Technical change of AKZ 4 KRG

The affected article is a mini feed-through terminal of our SAK screw connection series. Within an ATEX certification of the notified body SIRA we decided to not extend the ATEX certification of this product. The Ex - marking will be removed from the product.

Product image:

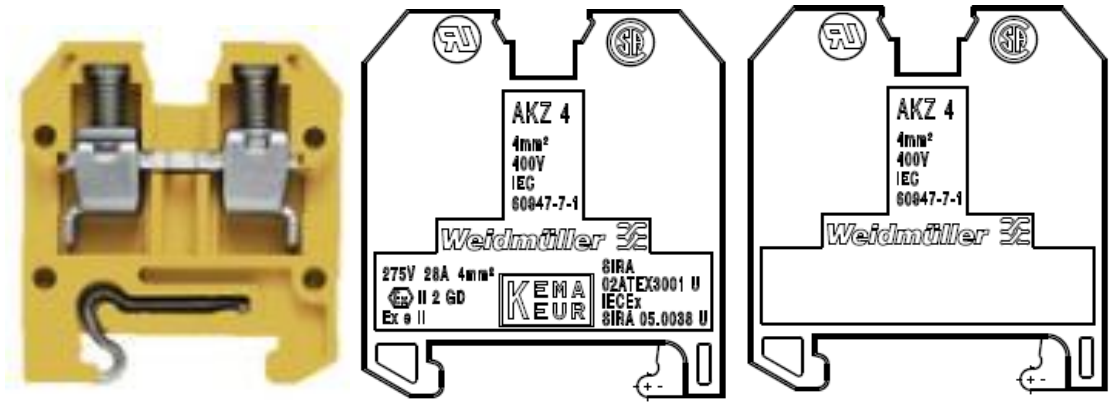
The product itself, material and form fit function are not affected. Only the printed ATEX information will be deleted and the terminal without printed ATEX information cannot be used in ATEX application.
